Index 17784

Pedestrian Detector Assembly Installation Details

Index 17784

Pedestrian Detector Assembly Installation Details

DETAIL "A"

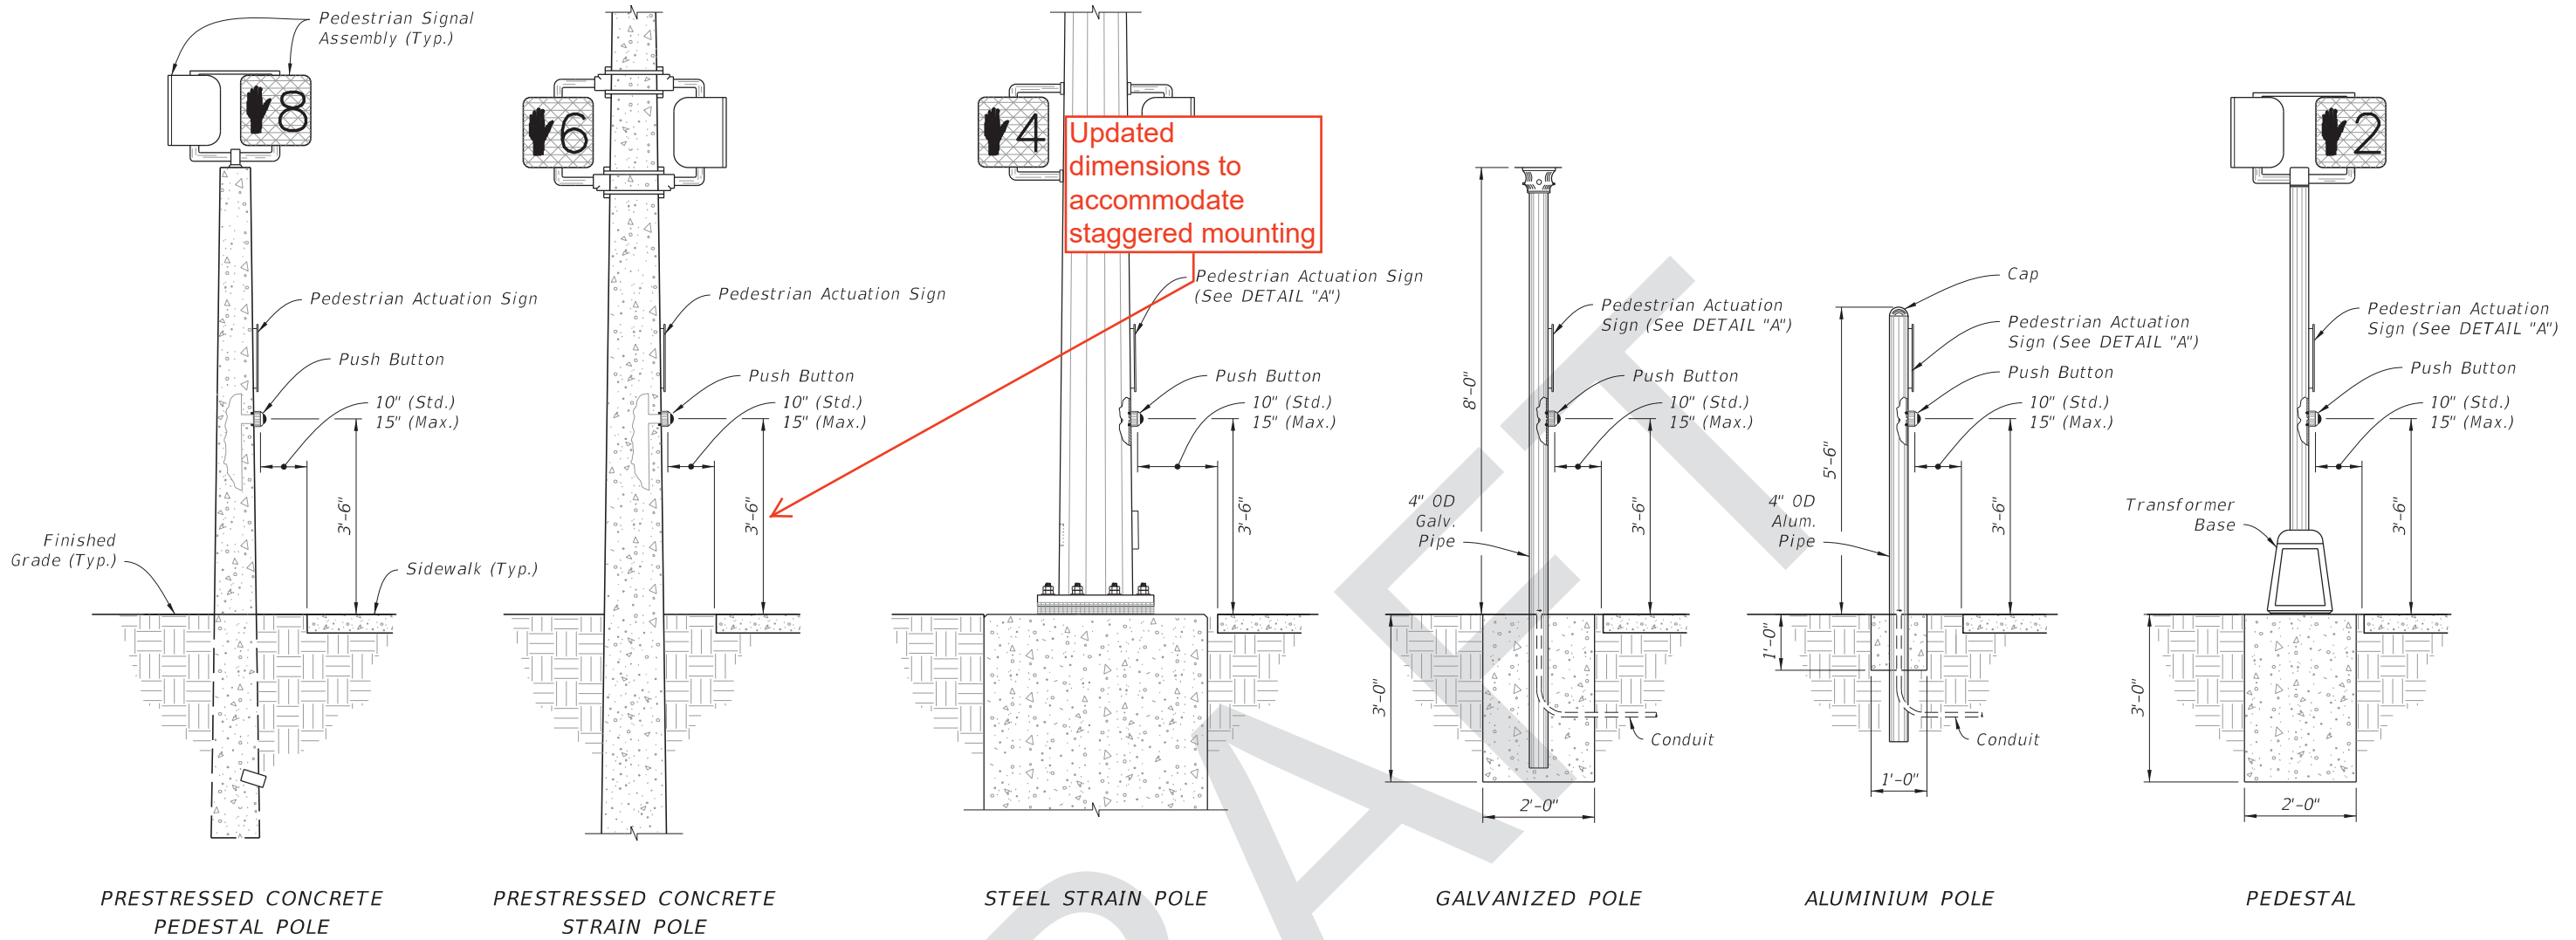
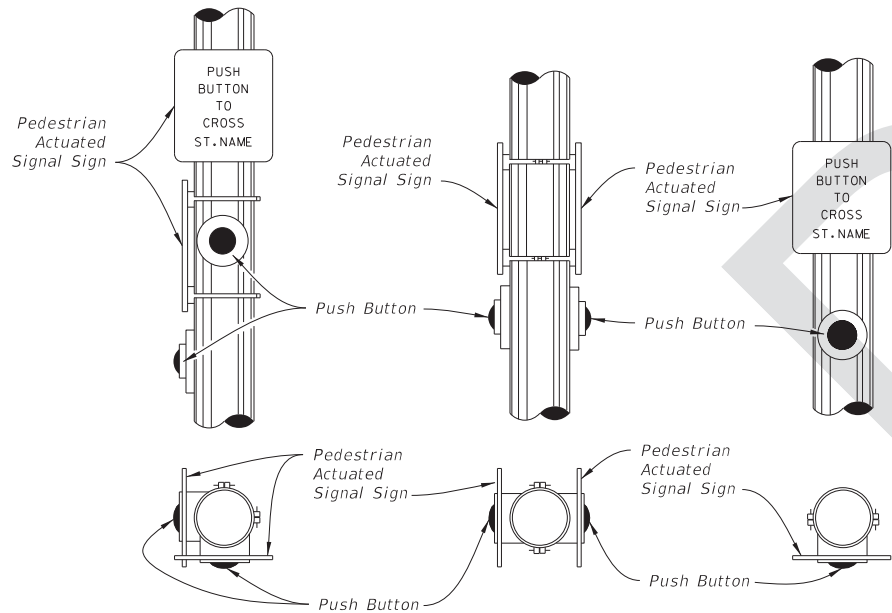
On Sheet 1 of 1:

1. If the center of the button is to be 3'-6" above the adjacent sidewalk, then the staggered mounting on the left example of Detail "A" would be in conflict. The mounting height should either be shown as an acceptable range of values or the staggered mounting should be deleted.
2. In Note 1, "Signs" is misspelled.
3. The street name used on the signs should represent the commonly used name of the street. For example, "Ulmerton Road" would be more descriptive than "SR 688", assuming that is what the street name signs use. I've even seen "hidden" state route designations used on signs – such as SR 55 for US 19.

1. Agreed, the guidelines indicate a maximum height of 48" to the center of the pushbutton. The Index will be updated to indicate a max. height of 4'-0" for a staggered installation.
2. Spelling will be updated.
3. Street Name is not included on the Index. No Change.

Updated dimensions to accommodate staggered mounting

DETAIL "A"

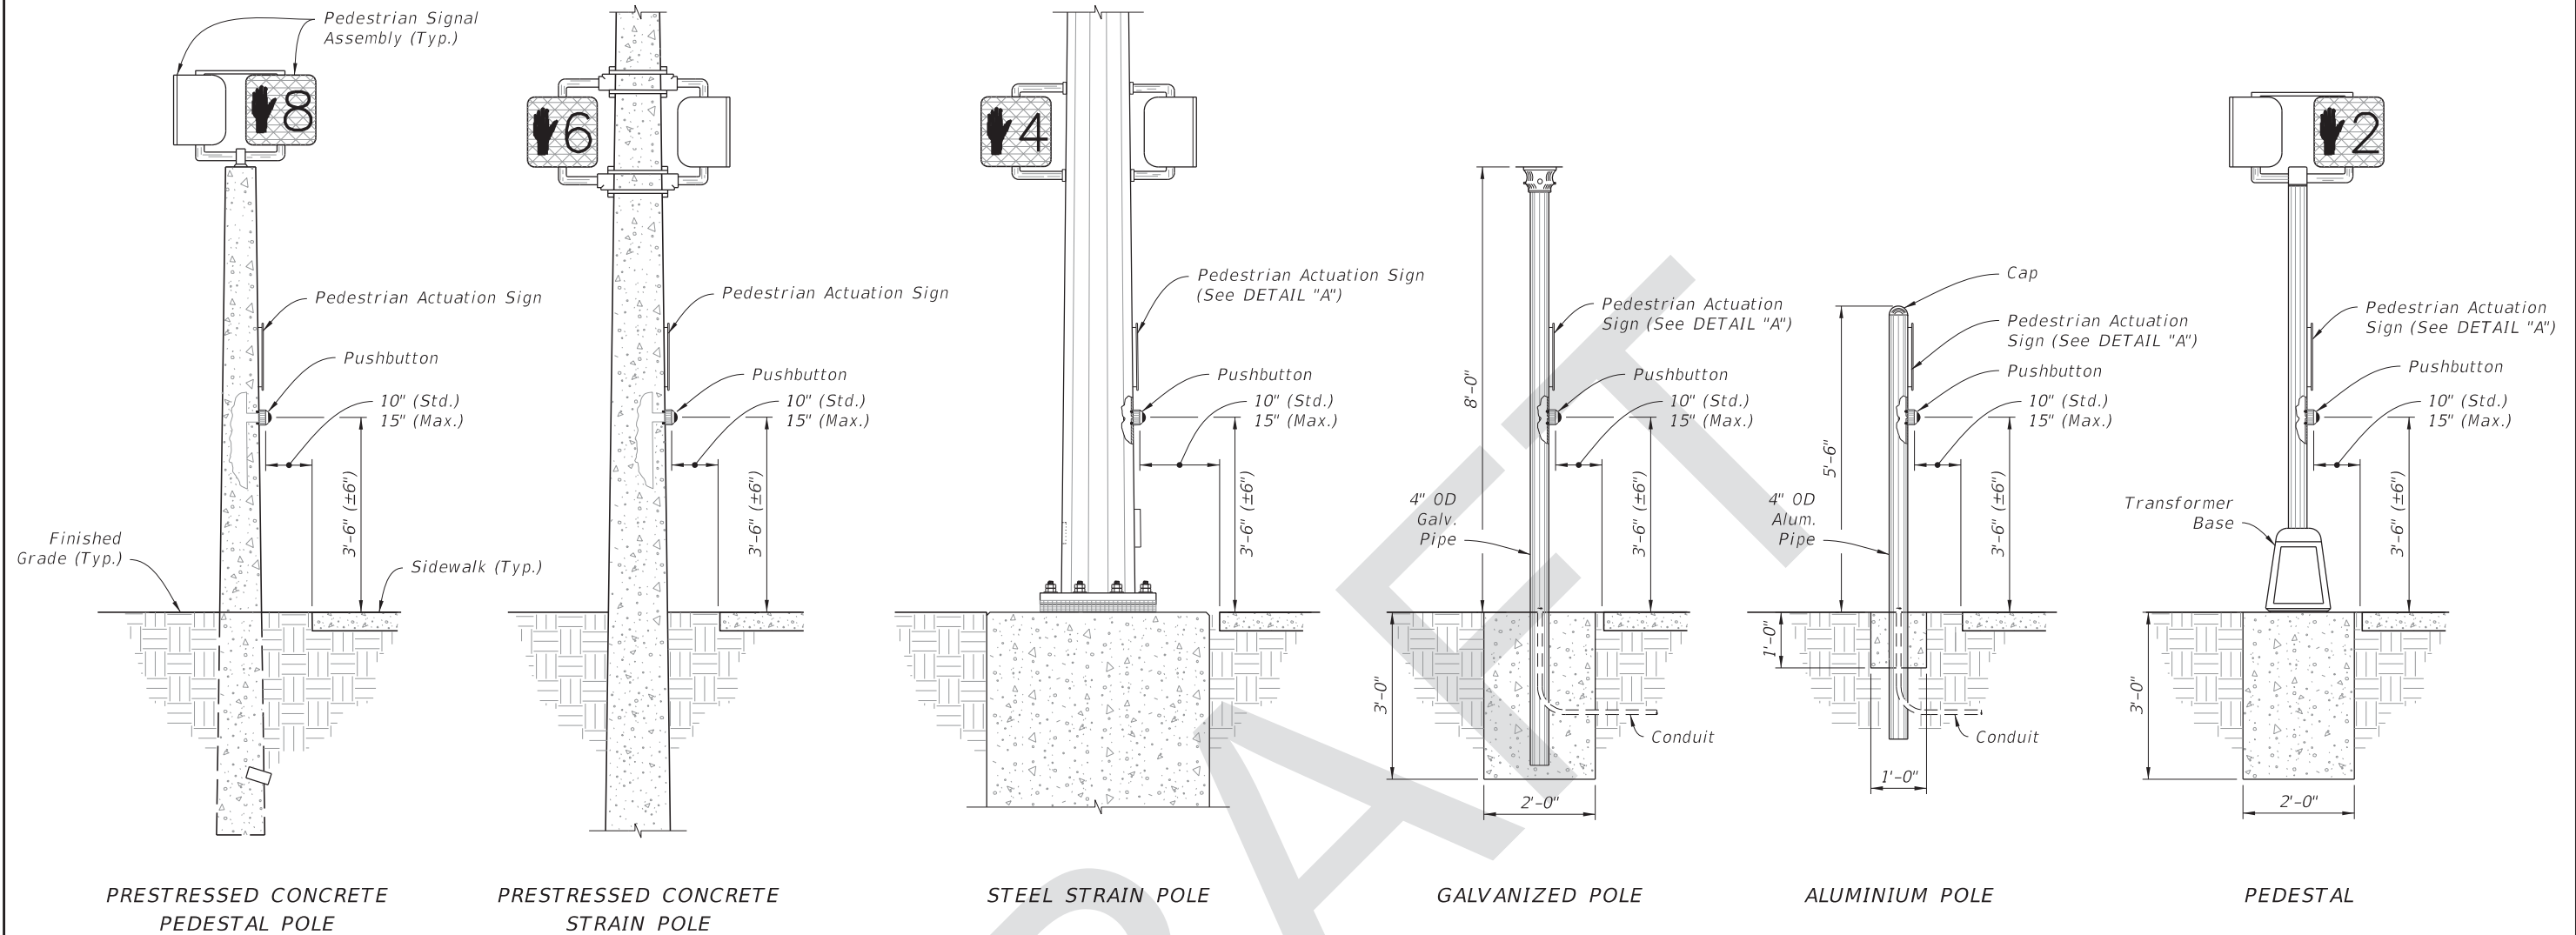
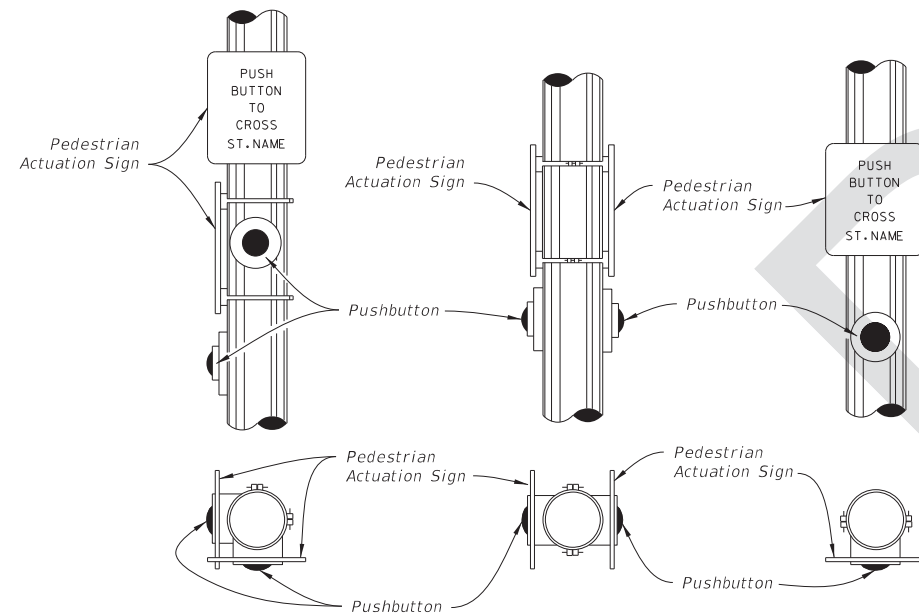
Sheet 1: Changed the horizontal reach of pedestrian detector push-button to 10" (Std.) / 15" (Max.); Rearranged sheet; Updated Notes.

To match ADA Standards, horizontal reach to pedestrian detector (push-button) must be changed from 15" (24" max.) to 10" max. over an obstruction (i.e., guardrail) or edge of sidewalk.
